**STAFF RECOMMENDATION
1112 Boscobel Street
June 16, 2021**

Application: Demolition; Show Cause
District: Belmont-Hillsboro Neighborhood Conservation Zoning Overlay
Council District: Lockeland Springs-East End Neighborhood Conservation Zoning Overlay
Base Zoning: R6
Map and Parcel Number: 08313018100
Applicant: James Crockett II, JAC Investments
Project Lead: Melissa Sajid, Melissa.sajid@nashville.gov

<p>Description of Project: The applicant requests demolition of a contributing building, demolished without a permit. Staff requests a show-cause hearing for Permit #2020055431, issued on September 17, 2020.</p> <p>Recommendation: Staff recommends the consideration of three votes.</p> <p>Demolition: Staff recommends disapproval of demolition; finding that demo does not meet Section III.B.2.b.</p> <p>Show Cause: Staff recommends that the Preservation Permit for the addition (#2020055431), DADU (#2020055451), and reconstruction with the previously approved addition (#202124465) be rescinded, finding that demolition took place outside of the scope of the permit and work on reconstruction has not yet begun.</p> <p>Reconstruction: Staff recommends the building be fully documented and rec

Figure 1. 1112 Boscobel Street.

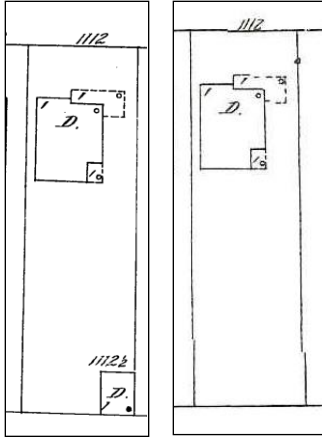
Background: The house at 1112 Boscobel is a c. 1900 Folk Victorian house (Figures 1 & 2) that contributes to the historic character of the Lockeland Springs-East End Neighborhood Conservation Zoning Overlay. The house appears on the 1908 Hopkins Map but does not appear on the earlier 1889 Hopkins Map. The house has been altered in the twentieth century, most notably with the enclosure of the front porch. While the subject property is not part of the nearby Edgefield or East Nashville National Register Districts, the house's date of construction and Victorian style featuring a hipped roof and corner porch form is noted as being typical of both districts.

BACK
3 1/8" = 1'-0"

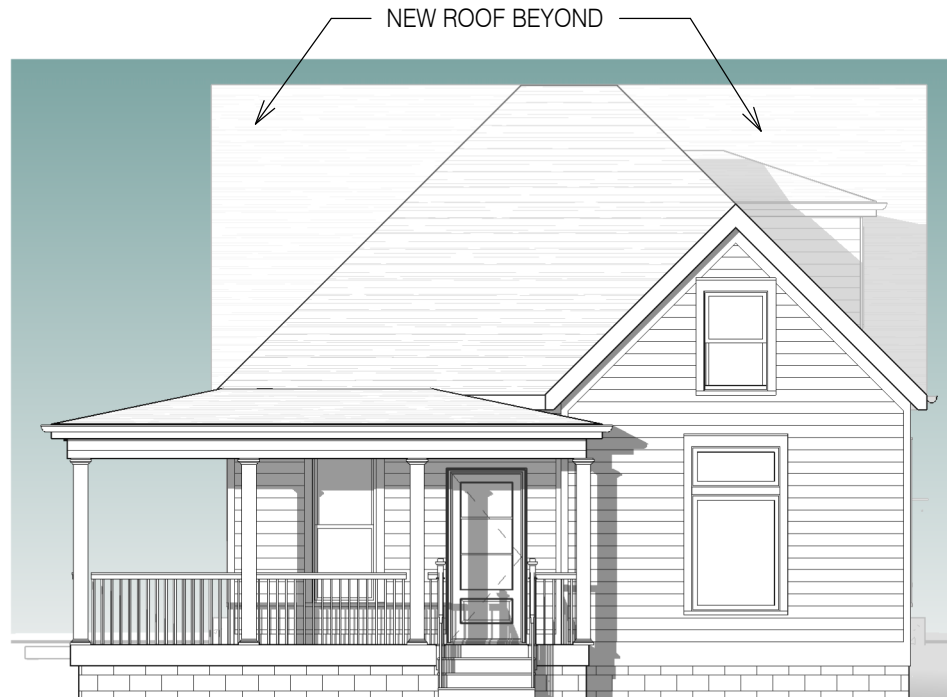
Windows may be different as construction. Ok because on rear facade. MB 1/25/2021
